**Stage 1 Quality Audit Report
Proposed Part 8 Residential
Development, Coolaghknock Glebe,
Kildare Town, Co. Kildare
For Kildare County Council**

Client:	Malone O'Regan Consulting Engineers
Document No:	231860-ORS-XX-XX-RP-TR-13g-006

Job: 231860 – Proposed Residential Development at Coolaghknock Glebe, Co. Kildare

Problem No.2: Accessible Car Parking Bay Throughout the Estate

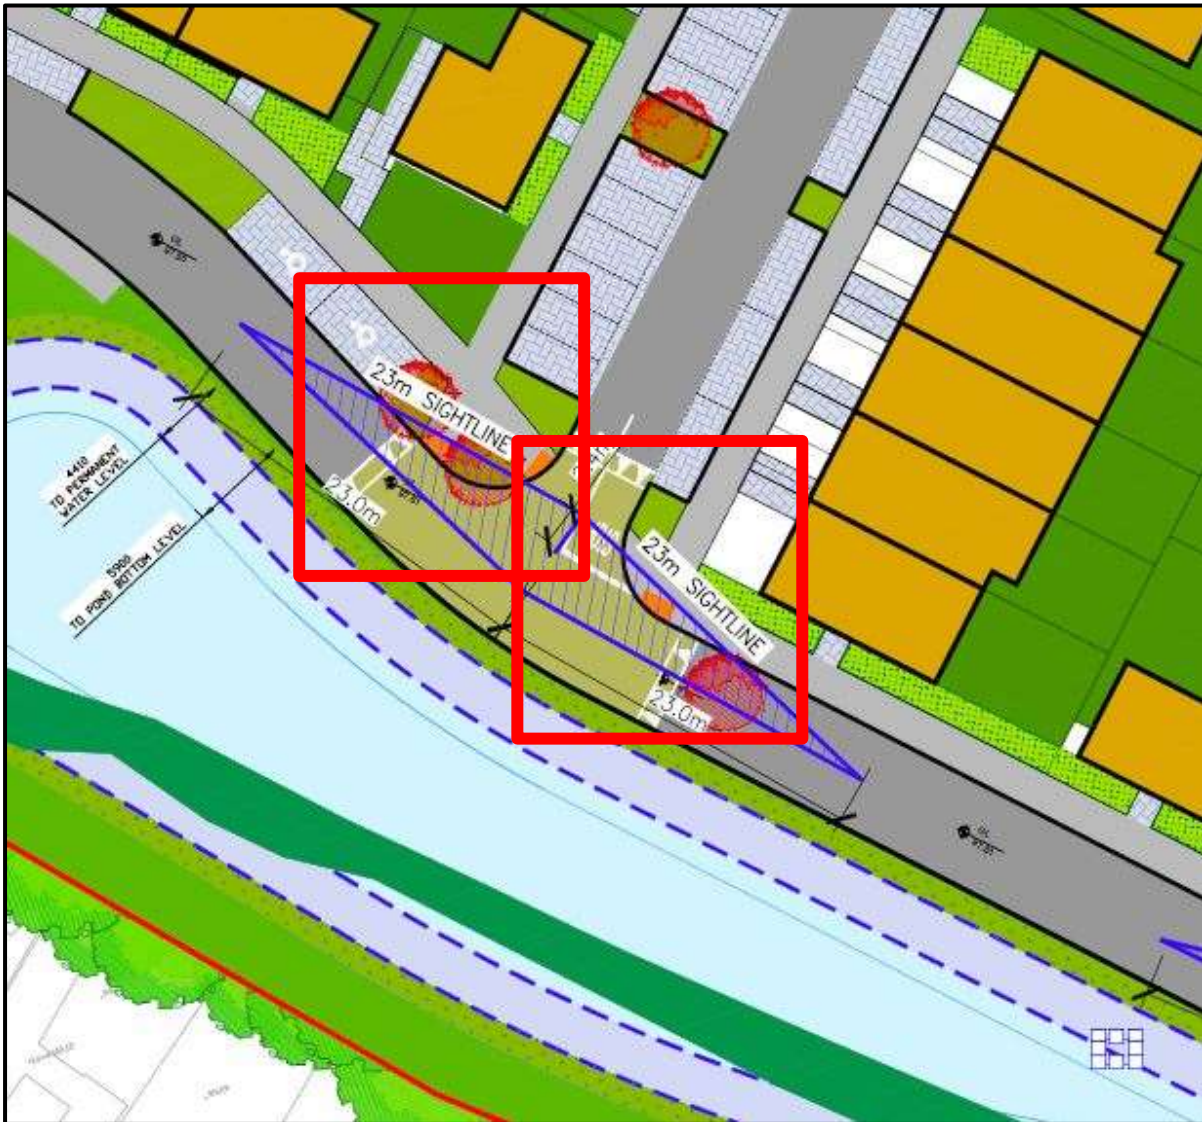
The audit team note that access to pedestrian paths from the disabled parking space is not facilitated by means of dropped kerbs or footpaths. These facilities aid users with specific mobility needs and the omission of dropped kerbs and connective paths may result in wheelchair users having to travel along the roadway to find a suitable location to mount the footpath which could increase the risk of conflicts with vehicles on the access road.

The audit team also note that the accessible parking bay identified is obstructed by other parking facilities like cycle parking facilities. This could result in hinderance while parking the vehicle into the accessible bay.

The design team should ensure that details and locations of dropped kerbs, connecting footpaths and tactile paving are provided for at the disabled parking spaces as recommended in the National Disability Authority publication 'Building for Everyone: A Universal Design Approach'. The design team should also ensure that other infrastructure or street furniture does not interfere with the safe use of the disabled parking bays.

Problem No.9: Protection to Attenuation Pond

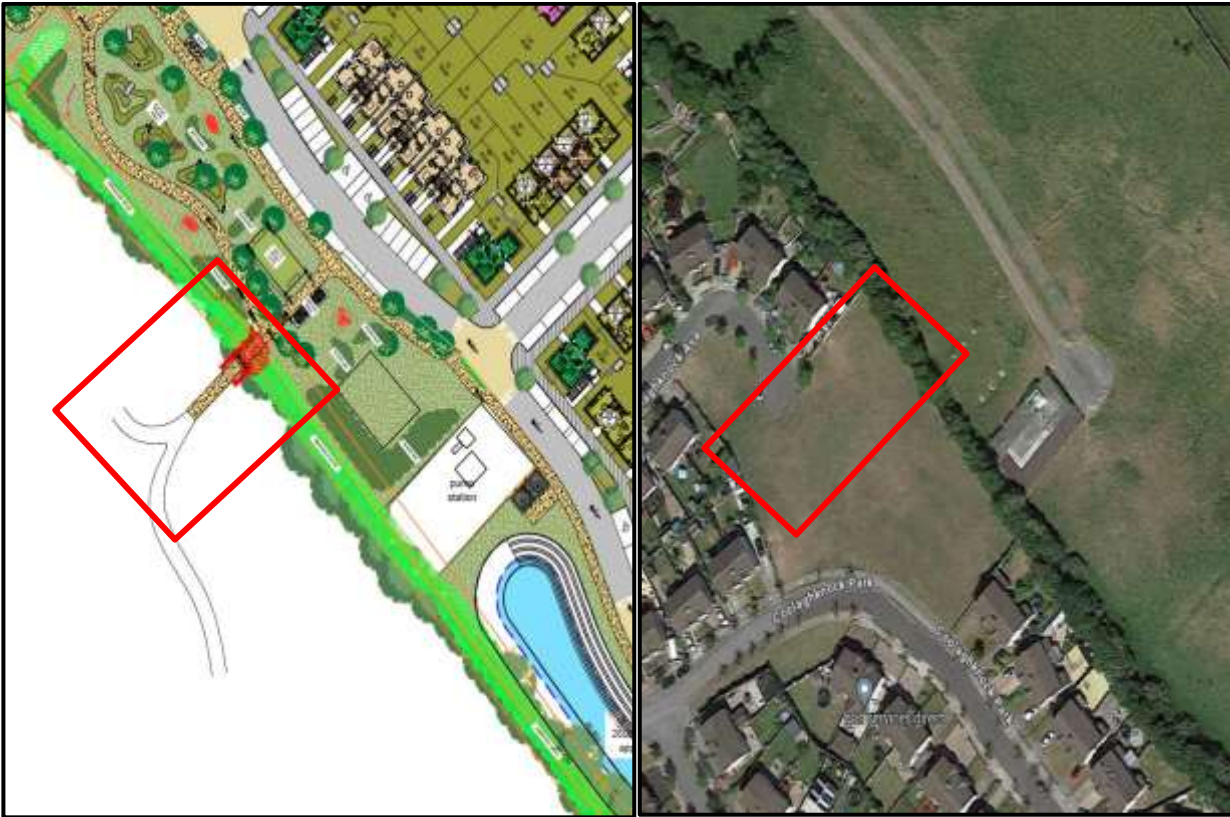
The audit team note that the attenuation pond runs parallel to the proposed access road and that no protection is provided for vulnerable users. The audit team would have concerns that a vulnerable road user could inadvertently enter the attenuation pond which could result in potential drowning type incidents for vulnerable users.

The design team should provide adequate protection to the attenuation pond is provided to prevent vulnerable users form entering the pond area.
